Access Compliance Report

Public Rights-of-Way

(Curb Ramps)

Intersection ID: 53762	Main Street: W_W_T_HARRIS_BV	Cross Street: SINGH_DR	Location: SE
ADA ID: AA0307F00C07	Ramp Type: Directional1	Initial Pass/Fail: Pass	Overall Compliance: No
		Severity Score: 10

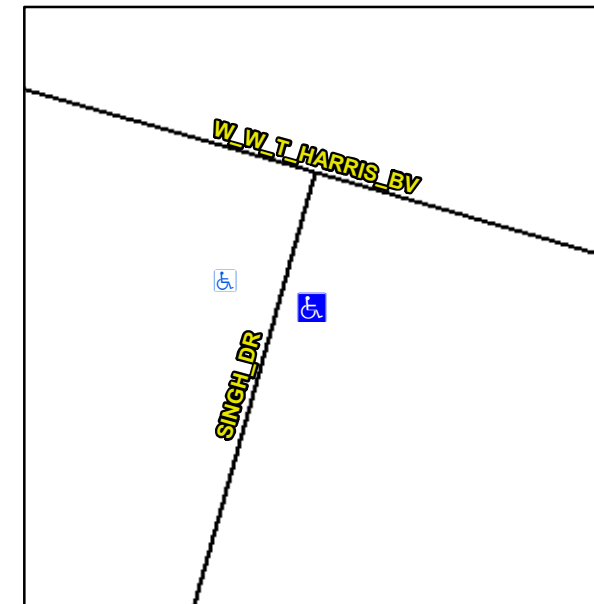
NO LNDG, NO SWs

**R304.2.1, R304.2.2-Perp, R304.3.2-
Para, R304.5.3, R304.5.2**

**Remove & Replace Entire Ramp.
Remove & Replace Gutter.**
